Kinross Road Structure Plan

Submission Review Report
September 2011

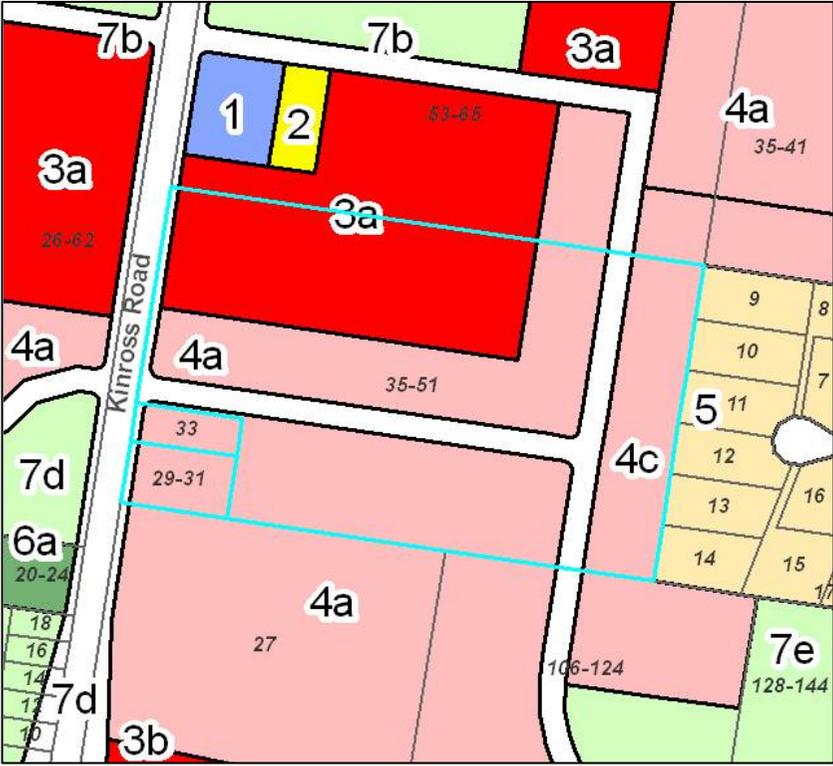
Issue Summary	Submission Reference No.	Submission Response
<p>5.5. 35-51 Kinross Road, Thornlands</p>  <ul style="list-style-type: none"> ▪ Landowner objection to the draft Structure Plan on the grounds that it will impact the ability to continue poultry farming operations on the property. ▪ The landowner has planted over 2,000 trees on the property with many being suitable for koala food. 	<p>4</p>	<p>Officer Comments</p>  <p>Source: Kinross Road Public Consultation Land Use Precinct Plan</p> <ul style="list-style-type: none"> ▪ The existing lawful use of the property for poultry farming is protected by the <i>Sustainable Planning Act 2009</i>. In addition the retention of the Poultry buffer identified in the Protection of the Poultry Industry Overlay will ensure existing use can continue to operate unimpeded until such time as it determines to relocate. (Refer to Submission Review Report 4.3 regarding the poultry buffer)

Table 5: Site specific		
Issue Summary	Submission Reference No.	Submission Response
<ul style="list-style-type: none"> ▪ Residents of Milner Place feel that they have a park on their back boundary and it cannot be built out. 		<ul style="list-style-type: none"> ▪ The area of vegetation on the site has not been identified as having habitat value or containing native vegetation that requires protection by either the ecological assessment undertaken for the draft Structure Plan or the SEQ Koala Habitat Values Mapping. To further investigate the values of this area, an inspection of the vegetation on the property by officers from the then Environmental Management Group occurred. This indicated that the vegetation has limited ecological value and does not contain native vegetation that requires protection on the following grounds: <ul style="list-style-type: none"> ▪ The vegetation is predominately exotic or introduced species (approximately 85%); ▪ The vegetation is not remnant vegetation with only a few trees representative of the remnant vegetation that would have been at this location; ▪ The vegetation does not have high value for koalas but is currently being used by koalas; and ▪ The biodiversity value of the vegetation is generally low due to the vegetation on the property being predominately exotic and the lack on vegetated connections to the property. (Refer to Submission Review Report 2.1 and 2.3 for further information regarding ecological/greenspace corridors within the structure plan area). ▪ The revised Structure Plan ensures larger lots greater than 1600m abutting the existing dwellings in Milner Place. A 5m buffer incorporating existing vegetation is also proposed along the rear of the boundary of the new lots adjoining existing lots in Milner Place. <p>Officers' Recommendations</p>

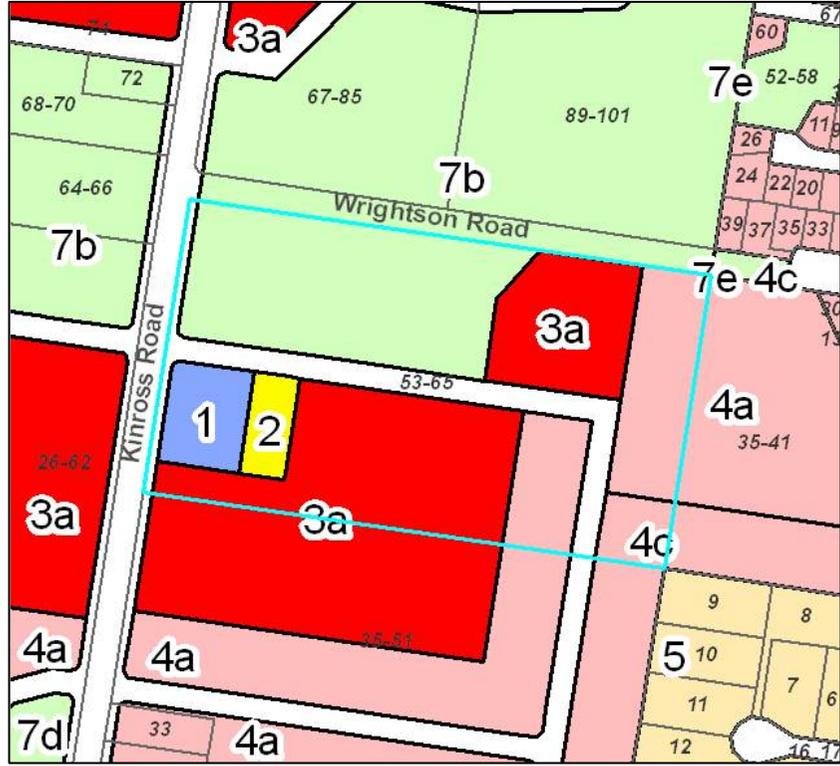
Issue Summary	Submission Reference No.	Submission Response
<p>5.6. 53 Kinross Road, Thornlands</p>  <ul style="list-style-type: none"> ▪ 65% of site allocated to Open Space with only approximately 35% for development resulting in a heavily reduced yield. ▪ Medium density should be located on major roads close to public transport and major amenities not in the middle of the overall plan. 	<p>231</p>	<p>Officer Comments</p>  <p>Source: Kinross Road Public Consultation Land Use Precinct Plan</p> <ul style="list-style-type: none"> ▪ The draft Structure Plan currently includes the subject land within the following land use precincts. They are: <ul style="list-style-type: none"> ▪ Medium density – Residential housing 3a Kinross Road; ▪ Mixed Use; ▪ Local Centre; ▪ Community Facilities; and

Table 5: Site specific		
Issue Summary	Submission Reference No.	Submission Response
<ul style="list-style-type: none"> ▪ Potential yield reduced from 100 residential lots to approximately 30 lots. ▪ Local centre and community purposes should be placed at a major road intersection – Boundary Road / Kinross Road. ▪ Should a local centre be necessary it should be located on Goddard Road. ▪ Land is cleared and there are no koalas. 		<ul style="list-style-type: none"> ▪ Urban residential housing ▪ Approximately 75% of the site has development potential with 25% included in the Greenspace / Local Park ▪ The draft plan currently proposes to locate the centre in a central location within the MPA adjacent to the Kinross Road trunk collector and Greenspace network ensuring high levels of accessibility to future residents of the MPA, by car, walkway, bicycle and public transport. Locating the centre adjacent to Boundary Road is likely to change the function of the centre as it could have the potential to attract commuter traffic using the arterial road network as well as the local catchment. This is contrary to Council’s centre strategy and will impact on the functionality of the arterial road network. Locating the centre in this location would also mean a significant proportion of the MPA is located outside the walkable catchment. This would also be the case if the Local Centre were to be located to Goddard Road (Refer to Submission Review Report 4.1 for more information). ▪ Locating the proposed Community Facility Precinct adjacent to the Local Centre with adjoining medium density residential housing and local park in a central location with good accessibility will assist in creating a vibrant multi purpose hub of Centre and Community activities. ▪ Land identified for local park and community facilities will be identified in Council’s draft Priority Infrastructure Plan and is expected to be acquired predominantly from funds collected through infrastructure charges. ▪ The proposed medium density residential precinct provides significant development opportunities facilitating up to 50

5.9. 67-85 Wrightson Road, Thornlands

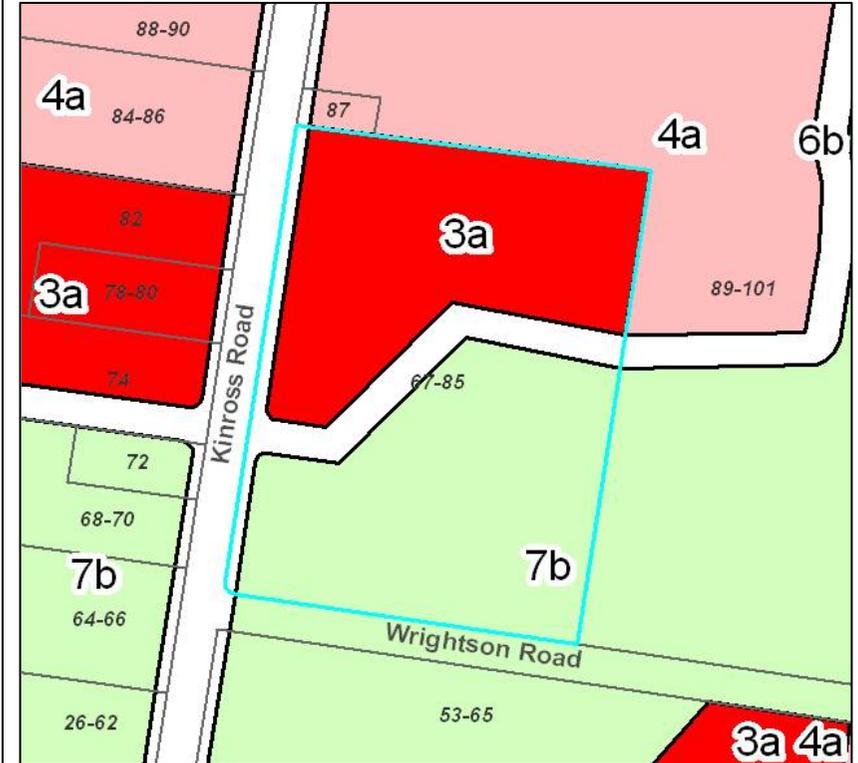
- The proposed east west corridor is inappropriately located on the subject land and should be relocated further to the south.

Table 5: Site specific		
Issue Summary	Submission Reference No.	Submission Response
		<p>within the Urban Residential Housing Precinct 4 – Sub Precinct 4a – Urban Housing.</p> <p>Officers' Recommendations</p> <ol style="list-style-type: none"> 1. That the submitters note the officers' comments. 2. That no changes be made to the draft Kinross Road Structure Plan. <p>Council Discussion</p> <ul style="list-style-type: none"> ▪ Council supports the officers' comments and recommendations. <p>Special Meeting Resolution</p> <ul style="list-style-type: none"> ▪ Adopt the officers' recommendation.

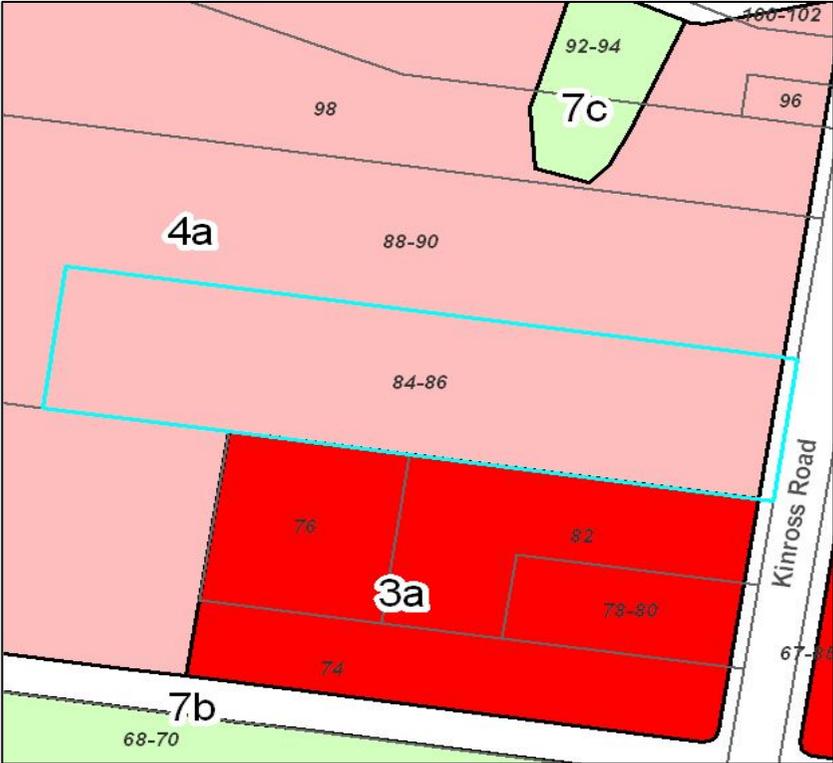
Issue Summary	Submission Reference No.	Submission Response
<p>5.10. 84-86 Kinross Road, Thornlands</p>  <ul style="list-style-type: none"> ▪ Inclusion of the subject site within the Urban Residential Housing Precinct is supported for the following reasons: <ul style="list-style-type: none"> ▪ The site will contribute to meeting dwelling targets expressed in the SEQ Regional Plan. ▪ The location of the subject site is well situated and 	<p>48</p>	<p>Officer Comments</p>  <p>Source: Kinross Road Public Consultation Land Use Precinct Plan</p> <ul style="list-style-type: none"> ▪ The subject land is appropriately within the Urban Residential Housing Precinct - Sub Precinct 4a – Urban Housing. No changes are proposed to the draft Structure Plan. <p>Officers' Recommendations</p> <ol style="list-style-type: none"> 1. That the submitters note the officers' comments.

Table 5: Site specific		
Issue Summary	Submission Reference No.	Submission Response
<p>suitable to deliver the identified outcomes for the 'Urban Residential Housing Precinct.'</p> <ul style="list-style-type: none"> ▪ The site's location and proposed designation is broadly consistent with the objective of providing a balance between koala habitat and protection of urban development. 		<p>2. That no changes be made to the draft Kinross Road Structure Plan.</p> <p>Council Discussion</p> <ul style="list-style-type: none"> ▪ Council supports the officers' comments and recommendations. <p>Special Meeting Resolution</p> <ul style="list-style-type: none"> ▪ Adopt the officers' recommendation.

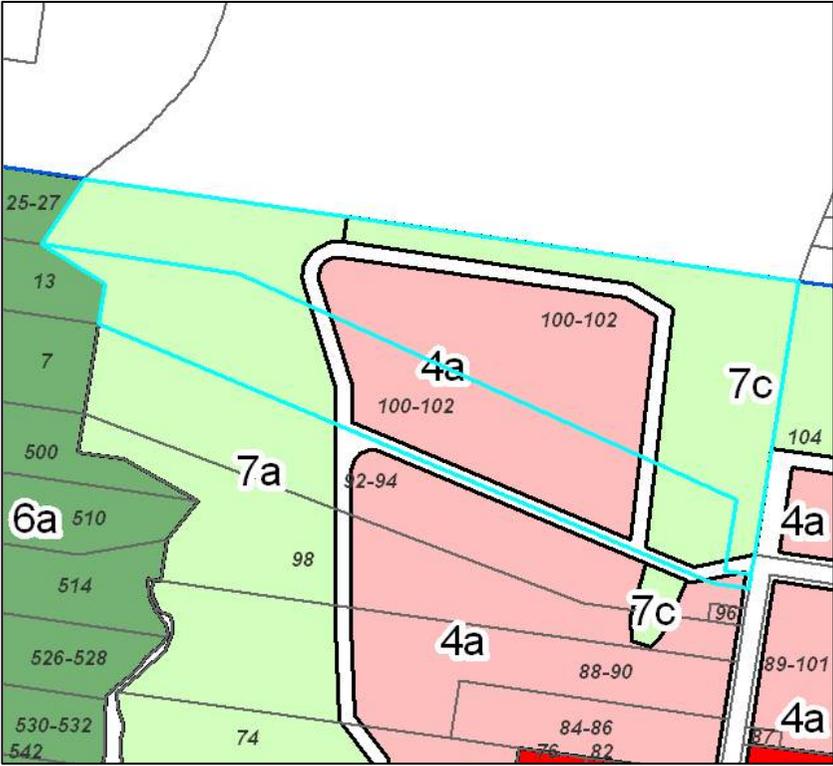
Issue Summary	Submission Reference No.	Submission Response
<p>5.12. 100-102 Kinross Road, Thornlands</p>  <ul style="list-style-type: none"> ▪ Comment received from the Koala Action Group does not support the development of this site. The site directly adjoins a contiguous area of recognised high value bushland for koalas (State Planning Policy 02/10 Koala Conservation in SEQ and Redlands Planning Scheme). The site is designated as a Koala Sustainability Area. 	<p>216, 326</p>	<p>Officer Comments</p>  <p>Source: Kinross Road Public Consultation Land Use Precinct Plan</p> <ul style="list-style-type: none"> ▪ The 21 hectare subject site is located adjacent to the northern boundary of the Mater Planned Area. The draft Structure Plan includes the site within the following land use precincts: <ul style="list-style-type: none"> ▪ Urban Residential Housing Precinct 4a; and ▪ Greenspace Network Precincts 7a and 7c.

Table 5: Site specific		
Issue Summary	Submission Reference No.	Submission Response
<ul style="list-style-type: none"> ▪ Detailed strategic submission lodged by Track Consultants on behalf of the landowner: Churches of Christ Queensland (CofCQ). ▪ The CofCQ is generally supportive of the intent and content of the draft Structure Plan. ▪ CofCQ are a not for profit organization that provides care and social housing to families, the elderly and people in need operating 137 facilities across Queensland employing 2,300 special staff. ▪ The CofCQ intend to develop the site to provide long-term housing targeted at the aged on low incomes that are in housing stress. There is a demonstrated community need for this facility. ▪ Two development applications currently lodged over the site seeking approval for: <ul style="list-style-type: none"> ▪ Aged Care Facility of 192 rooms; ▪ Retirement Village comprising 305 independent living units and ancillary services and facilities; ▪ 1000m² GFA local centre; ▪ 75 place child care centre; and ▪ 20 affordable housing units in a multiple dwelling ▪ The CofCQ owns the site and is committed to the development proposals for the site with funding support secured from other levels of government. It is not a speculative development proposal. ▪ Refinements to draft Structure Plan are suggested to better 		<p>A future local park is also located on the site.</p> <p>Residential Precinct Footprint</p> <p>1. Koala Conservation (western edge of urban residential footprint)</p> <ul style="list-style-type: none"> ▪ It is acknowledged that the bushland habitat immediately to the north of the site is one of the most significant area of core habitat within the Urban Footprint (SEQ Regional Plan 2009-2031) of the City. This extensive bushland habitat is a publicly owned and managed conservation reserve that supports a range of native fauna (including koalas) to survive in the north of the City despite the urbanisation that has occurred. The koala conservation values of this area are recognised by both State Planning Policy 02/10 Koala Conservation in SEQ and the Redlands Planning Scheme. ▪ The importance of the habitat and the movement opportunities along Hilliards Creek for koala conservation has been highlighted by research by the Department of Environment and Resource Management in 2008. This research found that the protection and enhancement of habitat that provides for the movement of koalas between urban and rural habitats is critical to reverse the declines and ensure the survival of the koala population in the Koala Coast. ▪ The Hilliards Creek habitat and movement corridor is critical for linking urban habitat to the north of the site with the large bushland habitats to the south, west and south-west towards Sheldon and Mount Cotton that are protected within the Regional Landscape and Rural Production Area (SEQ Regional Plan 2009-2031). It should be noted that this

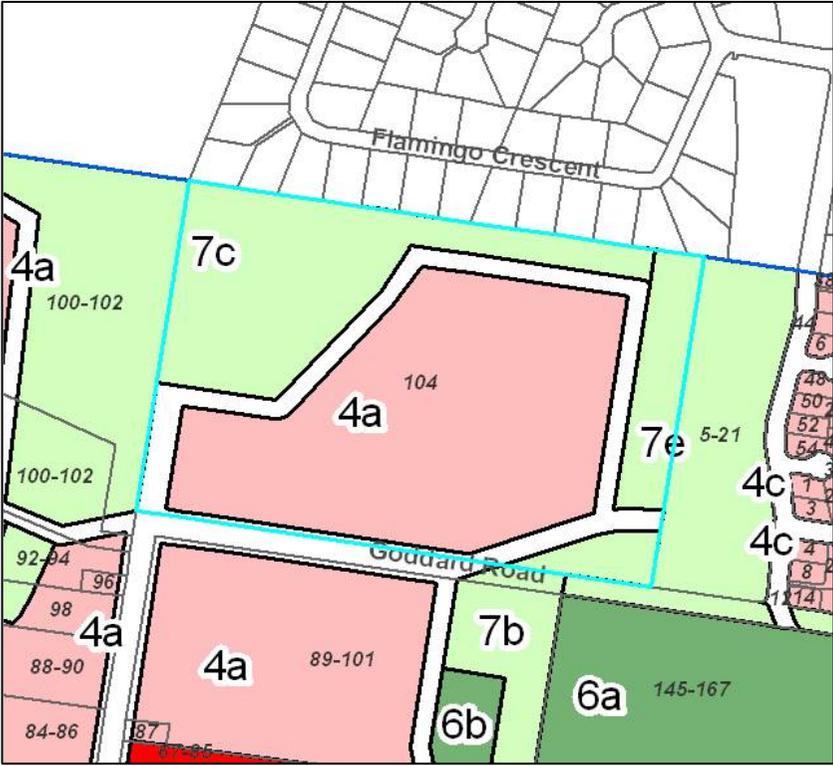
Issue Summary	Submission Reference No.	Submission Response
<p>5.13. 104 Kinross Road, Thornlands</p>  <ul style="list-style-type: none"> ▪ Land subject to an appeal in 2009 (Court No. 1303 of 2009). ▪ Draft plan generally consistent with Court Approval. ▪ Concern provisions in the draft plan in the strategic framework and overall outcomes of the draft code are too prescriptive in restricting no new lots or dwelling units within 	<p>332, 322, 2</p>	<p>Officer Comments</p>  <p>Source: Kinross Road Public Consultation Land Use Precinct Plan</p> <ul style="list-style-type: none"> ▪ It is recognised both the strategic framework and overall outcomes recognise urban development should not directly adjoin land in the Greenspace but be separated by the provision of an esplanade road. However the specific outcomes and probable solutions of the code, which form the basis for the assessment of a development recognises “to the greatest extent practicable” no new lots or dwelling units

Table 5: Site specific		
Issue Summary	Submission Reference No.	Submission Response
<p>a community title directly adjoining land in Greenspace precinct but are separated by the provision of an esplanade road.</p> <ul style="list-style-type: none"> ▪ Further clarification is required regarding a local park located in Sub Precinct 7e – Eastern Wetlands Corridor and Sub Precinct 7c – Northern Wetlands Habitat within the subject land. ▪ The proposed road movement network as shown on map 2 and also on Diagram 11 and Map 1 does not accord with the vehicular access points shown on the concept masterplan approval as part of the final orders. In particular the draft plan proposes a residential collector along the western boundary of the Ausbuild land leaving from Kinross within the existing electricity easement. ▪ Map 4 – Minor inconsistencies with the Infrastructure Agreement with Allconnex ▪ It should not be the intent for the Structure Planning process to effectively prohibit all development until a Structure plan has been finalised and adopted. 		<p>within a community title directly adjoin land within the Greenspace Precinct but are instead separated by the provision of an esplanade road. This allows sufficient flexibility for the specific attributes of the particular development site to be considered necessary.</p> <ul style="list-style-type: none"> ▪ Map 1 Kinross Road Structure Plan Area – Land Use Precincts identifies the proposed land use pattern for the Kinross Road Area. The plan identifies the locations of both local and district recreation parks. The map clearly indicates no local recreation park is to be provided within the subject land. No changes are necessary. ▪ The draft plan indicates Council’s preferred layout to access the subject land from a proposed roundabout located on the corner of Goddard Road and Kinross Road. This is also consistent with advice received from Energex that it generally prefers to co-locate its transmission lines within road reserves wherever practicable. ▪ Map 4 provides an illustrative guide of Council’s preferred infrastructure layouts for the Kinross Road area for portable water supply, wastewater disposal systems and trunk stormwater management infrastructure. The map is referenced in a note in the Structure Plan to assist applicants addressing specific outcomes 3.1 <p>3.1 (1) Uses and other development are serviced by infrastructure including –</p> <ul style="list-style-type: none"> (a) reticulated water (b) reticulated sewerage (c) stormwater management systems.

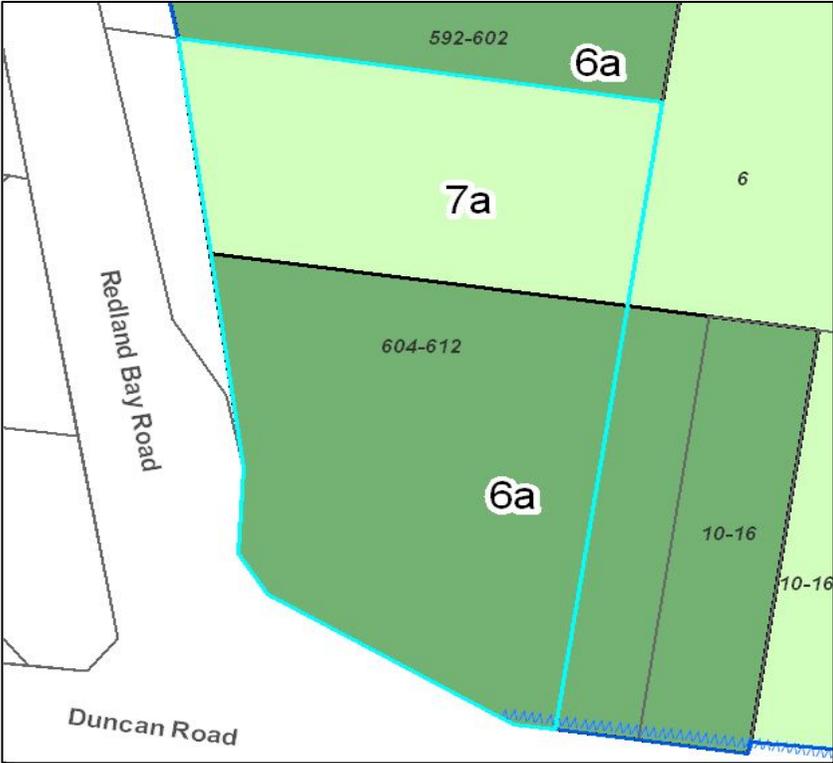
Issue Summary	Submission Reference No.	Submission Response
<p>5.15. 604 Redland Bay Road, Alexandra Hills</p>  <ul style="list-style-type: none"> ▪ Site purchased with intent to develop a service centre type development. ▪ Development would only occupy portion of the site with the remainder being able to be rehabilitated to promote and support environment. 	<p>240</p>	<p>Officer Comments</p>  <p>Source: Kinross Road Public Consultation Land Use Precinct Plan</p> <ul style="list-style-type: none"> ▪ The 35,220m² site is located at 604 Redland Bay Road at the intersection of Redland Bay Road and Boundary Road ▪ Land to both the east and north of the subject land is proposed for inclusion in the Greenspace and Bushland Living Precinct. Land immediately to the west of the site across Capalaba Redland Bay Road is included in the Park

Table 5: Site specific		
Issue Summary	Submission Reference No.	Submission Response
<ul style="list-style-type: none"> ▪ Request structure plan be amended to facilitate the establishment of proposed service centre. ▪ Site is cleared and has no significant constraints. ▪ Ideally located on two major roads for service station / local centre. ▪ No similar centre exists in the immediate area to support the future population of Kinross Road. ▪ Zoning and land use designation of the KRSP be amended to facilitate a Local Centre designation. 		<p>Residential Zone, Land to the south of the lot and Boundary Road is predominantly included in the Rural Non Urban and Regional Landscape and Rural Production area of the South East Queensland Regional Plan.</p> <ul style="list-style-type: none"> ▪ The lot is predominantly cleared but is affected by a number of overlays including the Bushland Habitat Overlay, Flood Stormwater and Drainage Combined Land Overlay, Landscape Overlay, Road and Rail Noise Overlay etc. ▪ Currently the draft Structure Plan includes the northern part of the subject land within the Bushland Living Precinct (Environmental Protection Zone) with the southern section of the lot proposed for inclusion in the Greenspace Precinct (Open Space Zone). ▪ The consultant submission lodged on behalf of the landowner proposes a service centre on the south west corner of the site with the balance of the lot potentially rehabilitated with appropriate koala habitat trees. ▪ The accompanying economic assessment indicates the subject site has the potential to serve a large catchment based on its exposure to Redland Bay Road and Boundary Road as well as a local catchment. ▪ There are significant planning concerns with the proposal. These include: <ul style="list-style-type: none"> ▪ The proposal is inconsistent with Council's centre planning and hierarchy which seeks to actively protect the primacy of the City's centre by discouraging out of centre development;

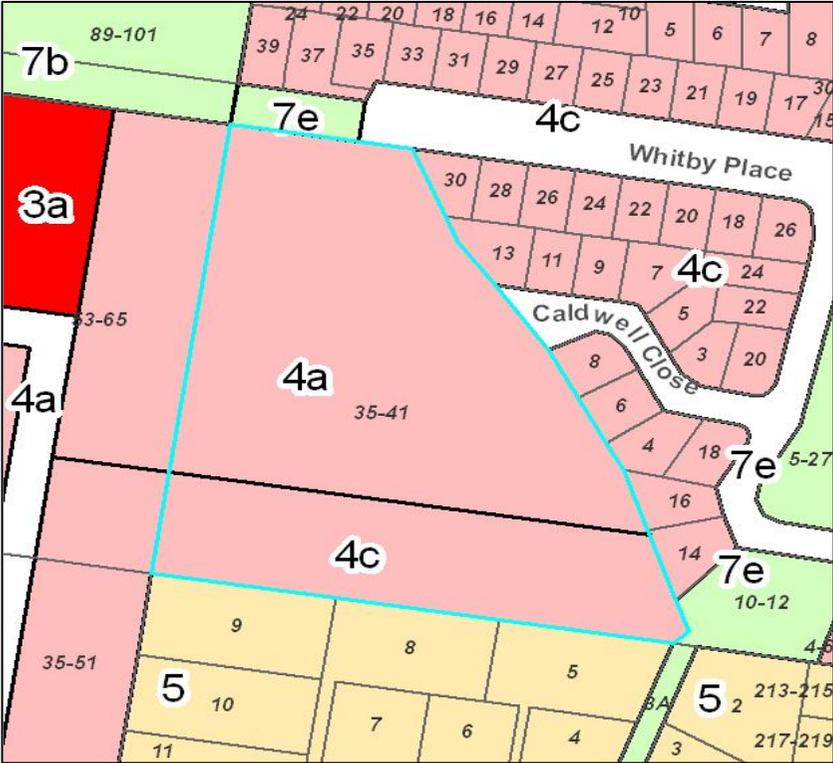
Issue Summary	Submission Reference No.	Submission Response
<p>5.17. 35-41 Wrightson Road, Thornlands</p>  <ul style="list-style-type: none"> ▪ Support proposed inclusion of the subject land within the Urban Residential Housing Precinct as a logical extension of existing urban development to the west of Panorama Drive. ▪ The site's inclusion within the Protection of the Poultry Industry Overlay may restrict its development in the short term, should the poultry shed remain operational. Request 	<p>277</p>	<p>Officer Comment</p>  <p>Source: Kinross Road Public Consultation Land Use Precinct Plan</p> <ul style="list-style-type: none"> ▪ The subject land is appropriately located within the Urban Residential Housing Precinct – Sub Precinct 4a – Multiple Locations. No changes are proposed to the draft Structure Plan. ▪ Refer to Submission Review Report 4.3 addressing the Protection of the Poultry Industry Overlay within the Structure

Table 5: Site specific		
Issue Summary	Submission Reference No.	Submission Response
the removal of the site from the overlay.		<p>Plan area.</p> <p>Officers' Recommendations</p> <ol style="list-style-type: none"> 1. That the submitters note the officers' comments. 2. That no changes be made to the draft Kinross Road Structure Plan. <p>Council Discussion</p> <ul style="list-style-type: none"> ▪ Council supports the officers' comments and recommendations. <p>Special Meeting Resolution</p> <ul style="list-style-type: none"> ▪ Adopt the officers' recommendation.
